ADDENDUM NO. 1

ISSUE DATE: September 7, 2023

PROJECT: City of Slaton
Senior Citizen Center

A2.1

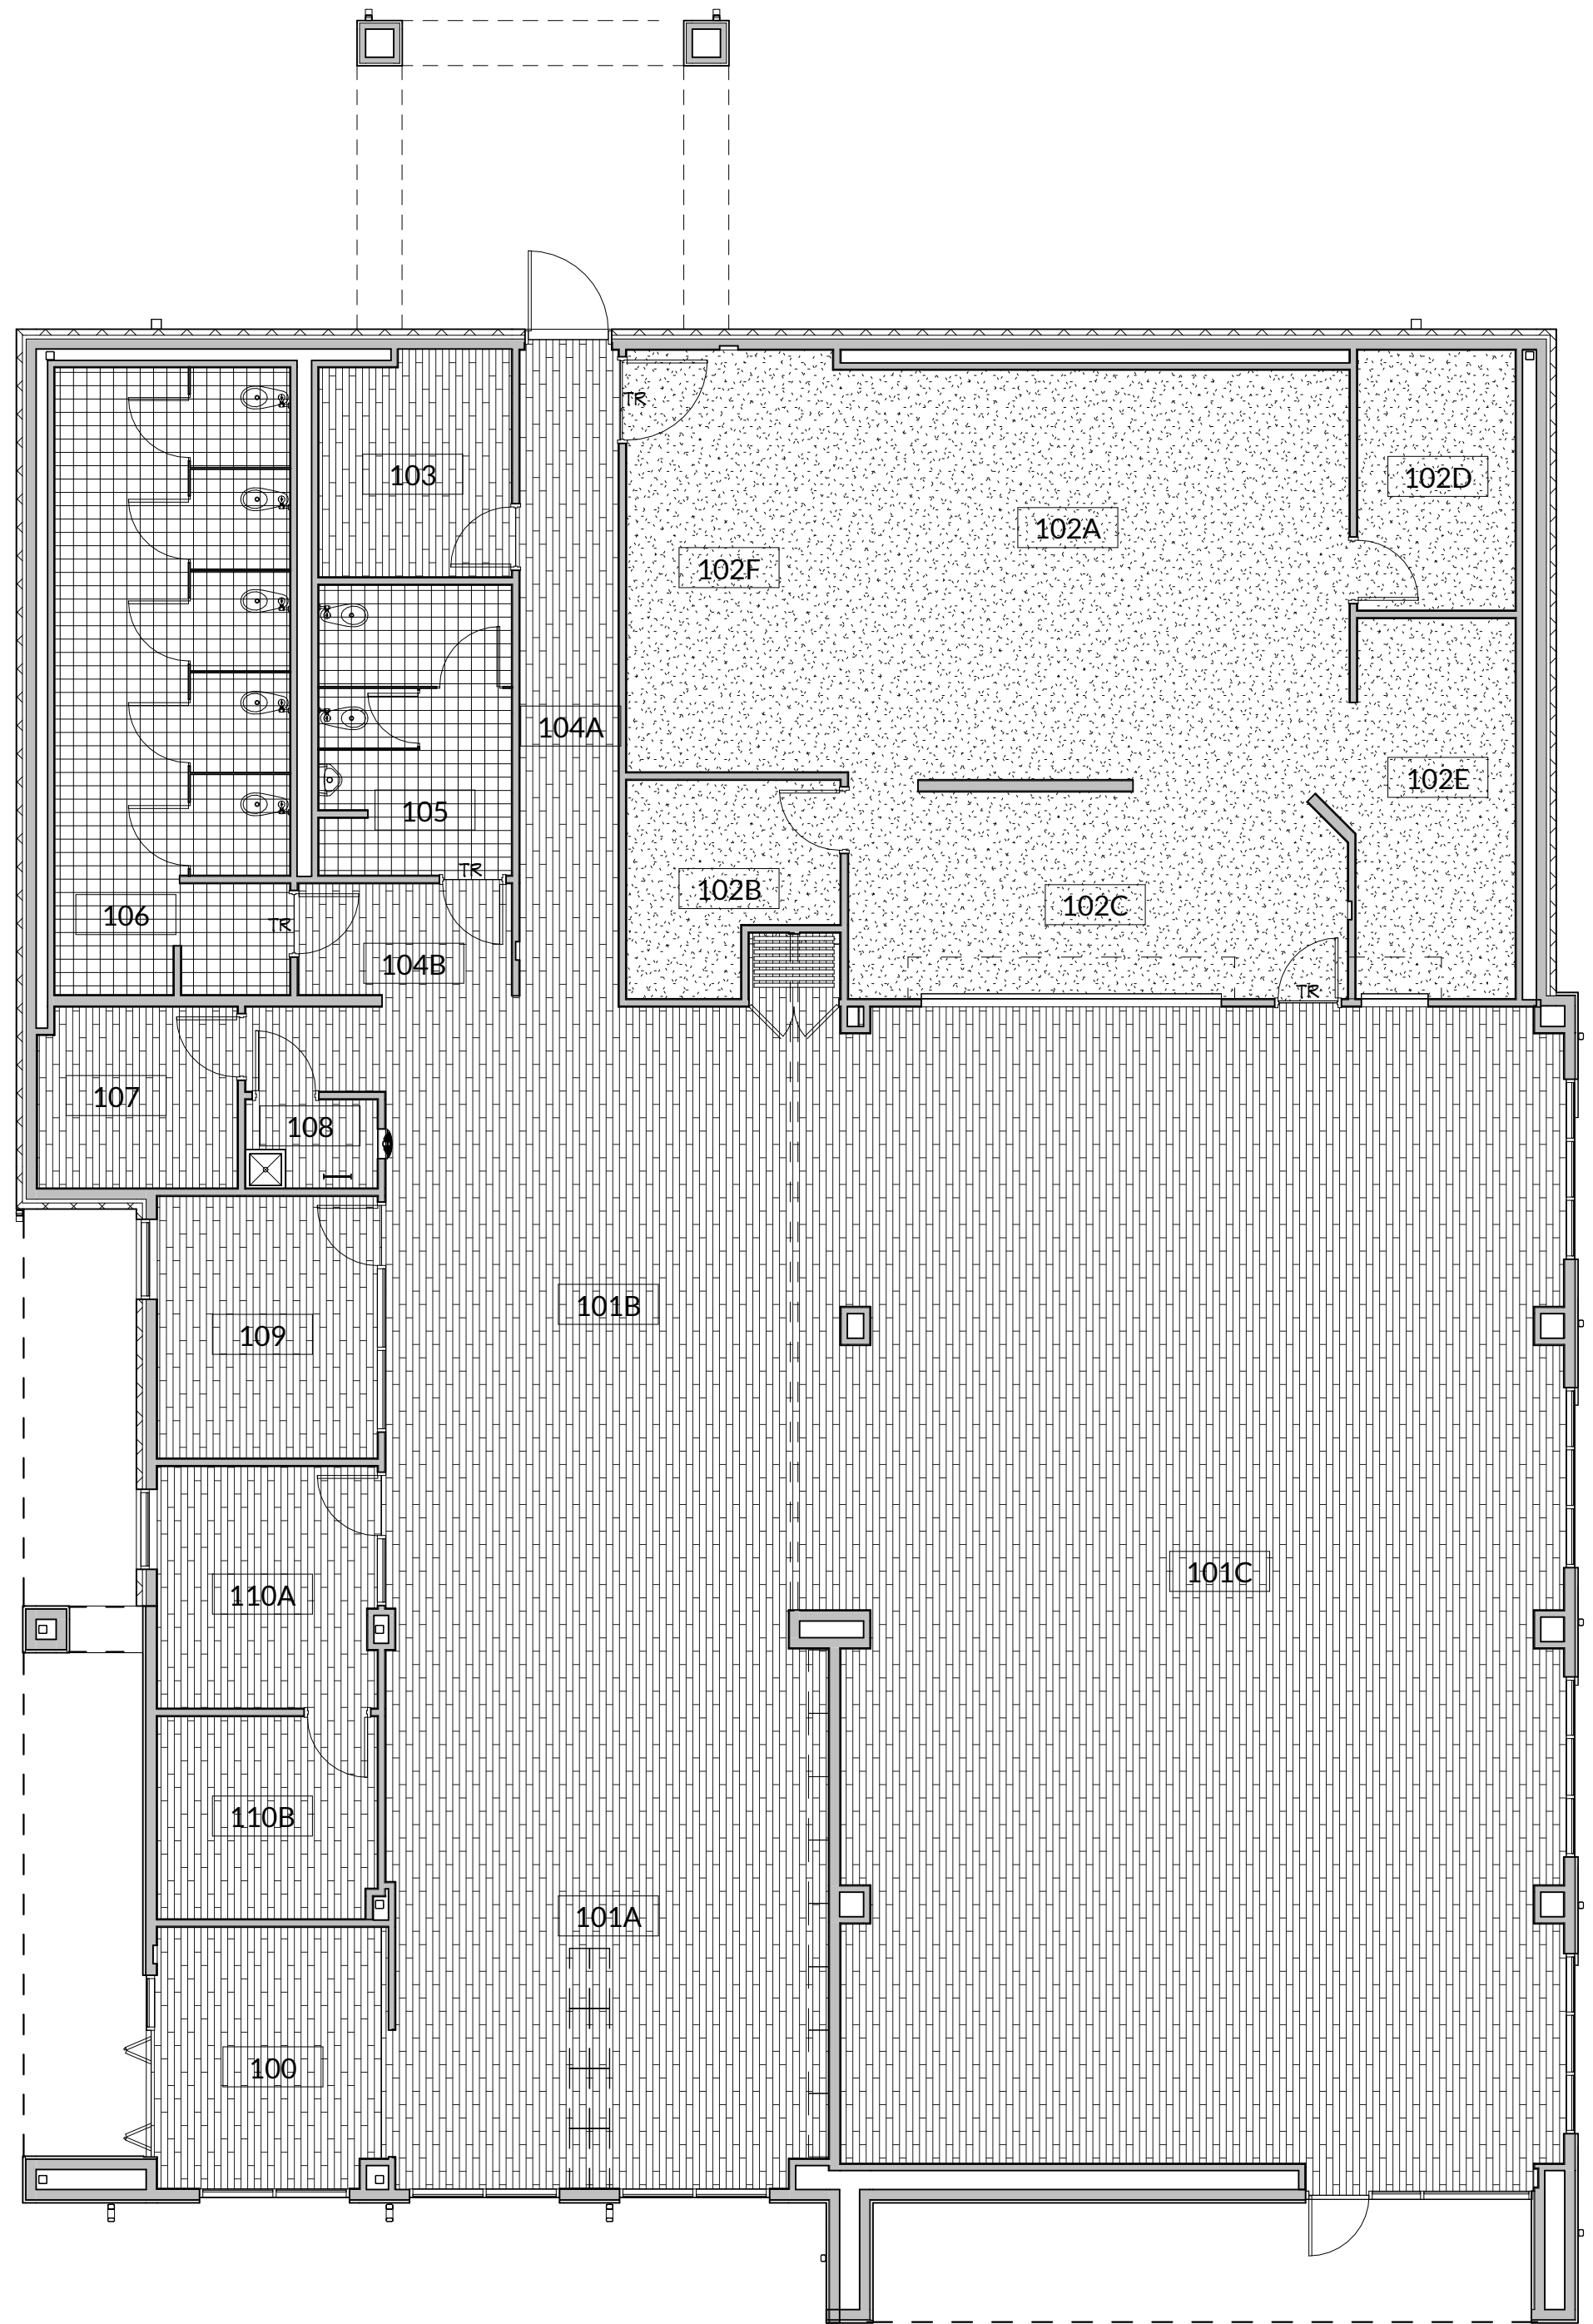
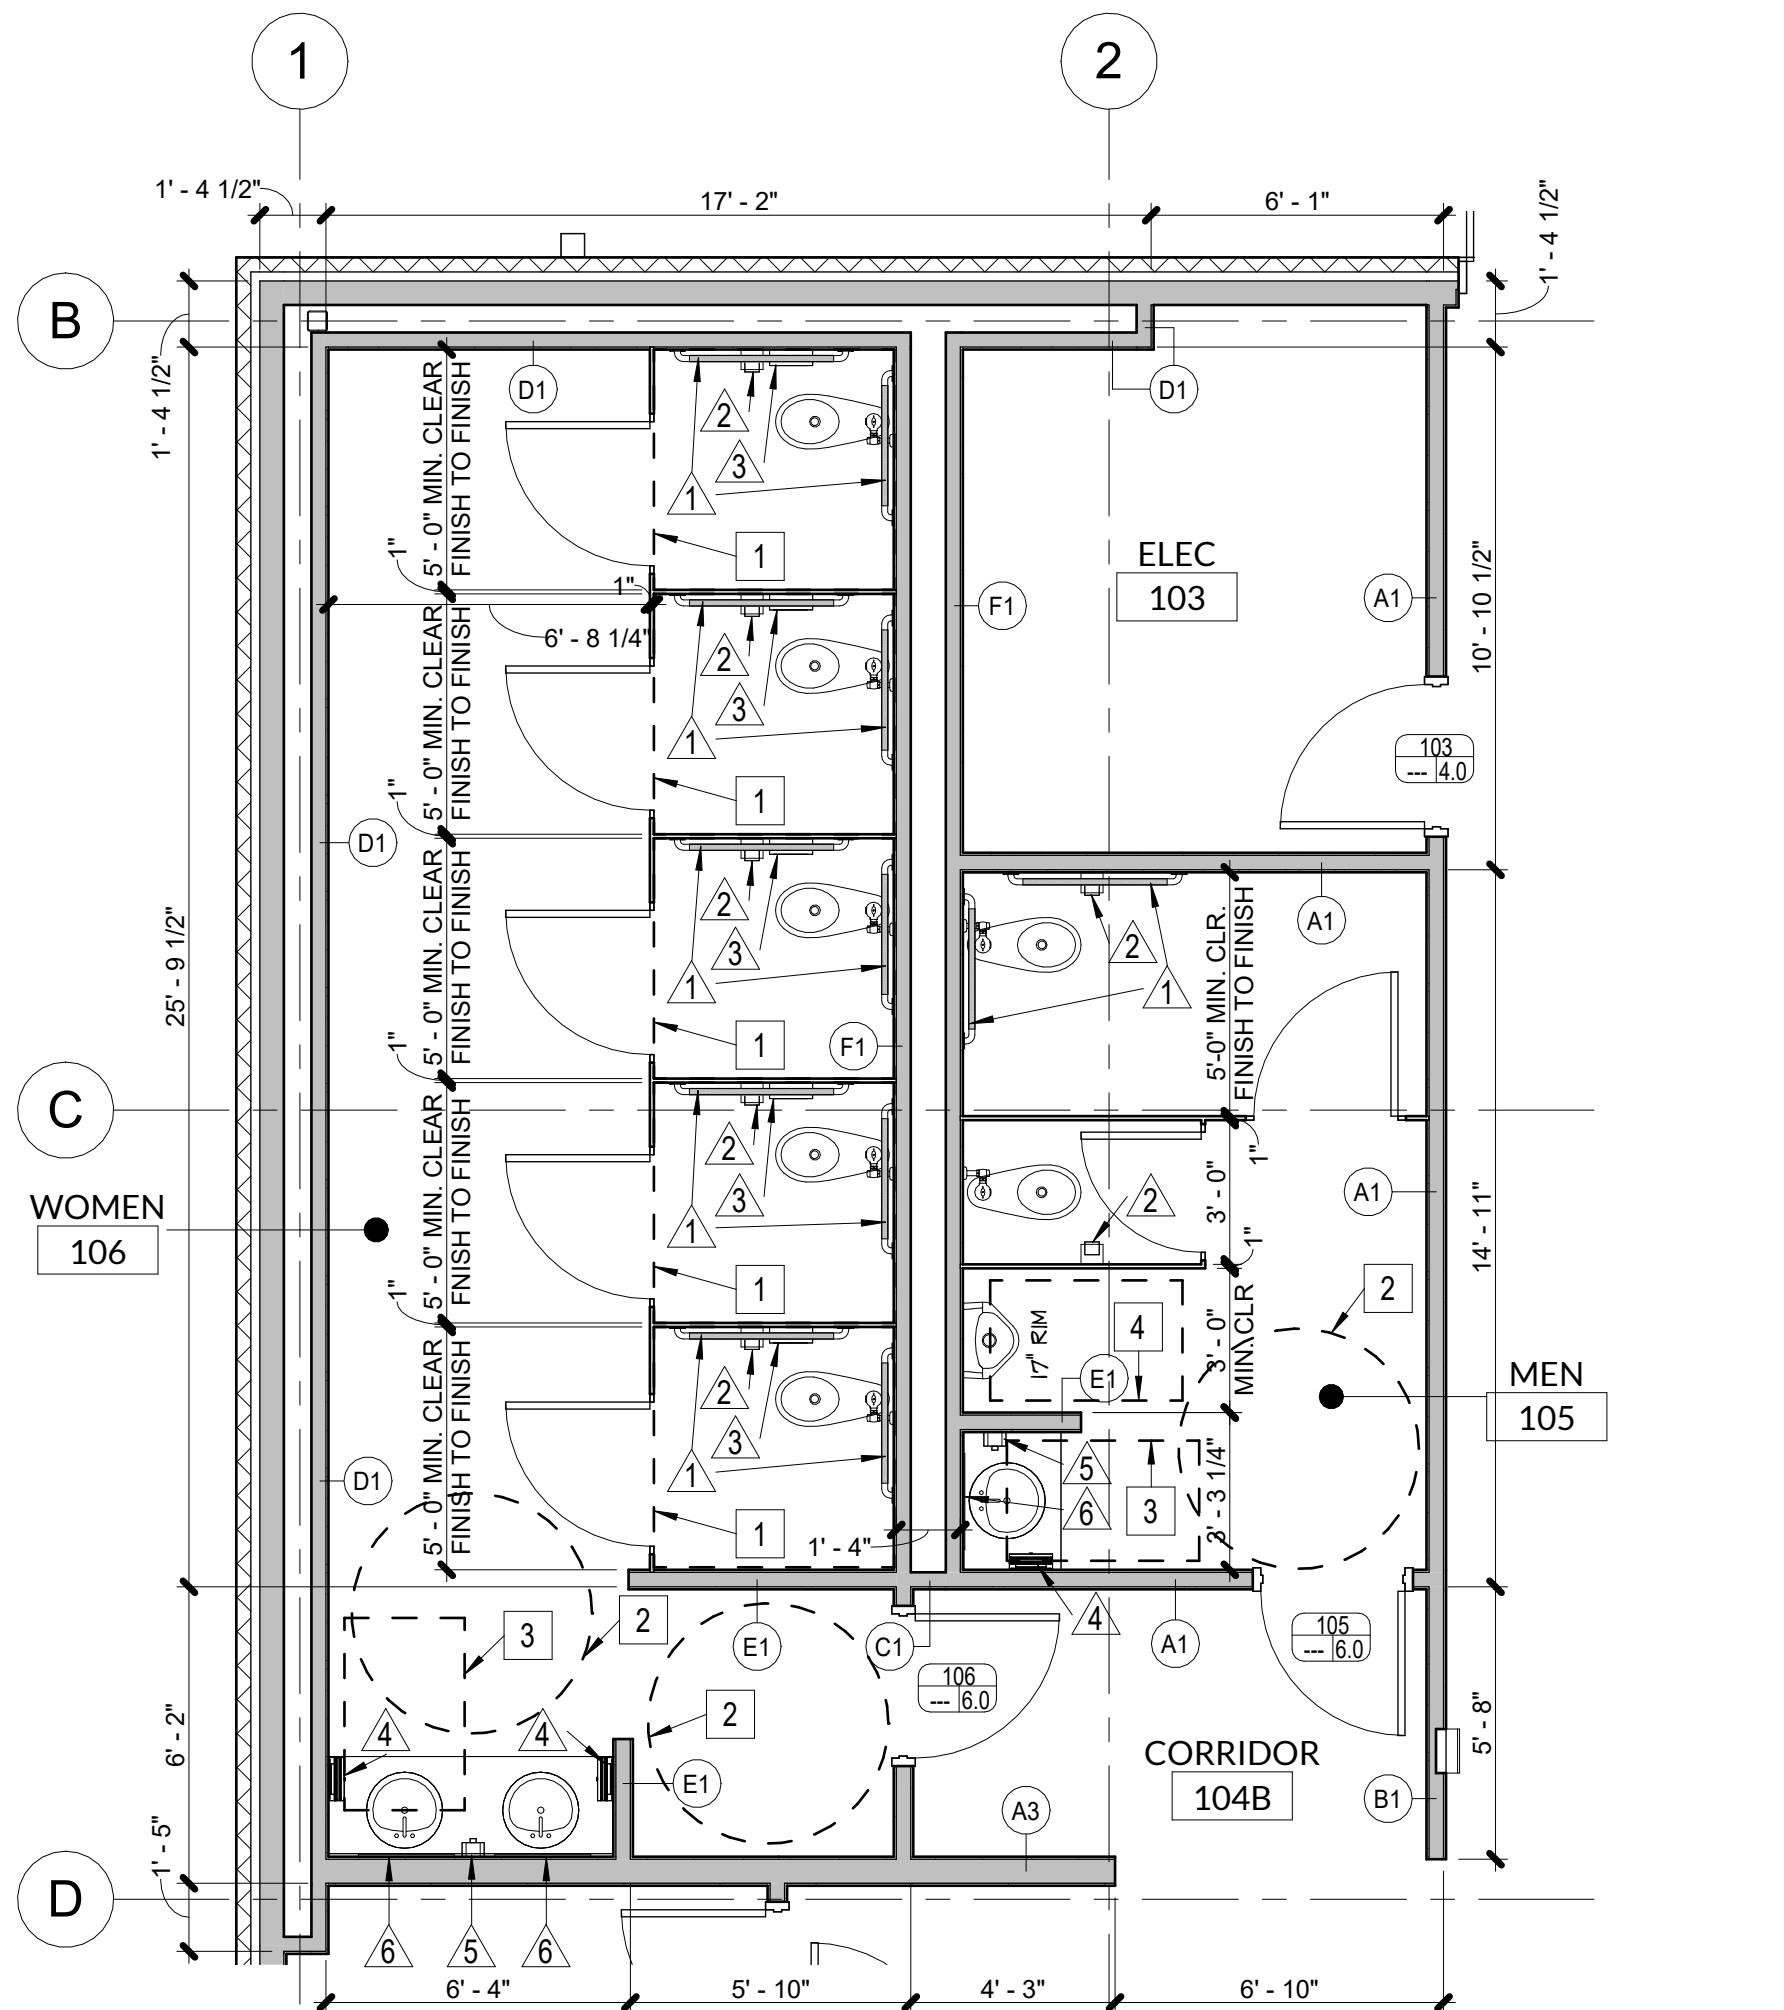
- Item #D1** **Sheet A2.1** - Replace sheet with attached A2.1 dated 09-07-2023. Clarification provided in Room Finish Schedule Legend.
- Item #D2** **Sheet S1.0** - REPLACE sheet with attached S1.0 dated 09-07-2023. ADDED concrete porches and associated details.
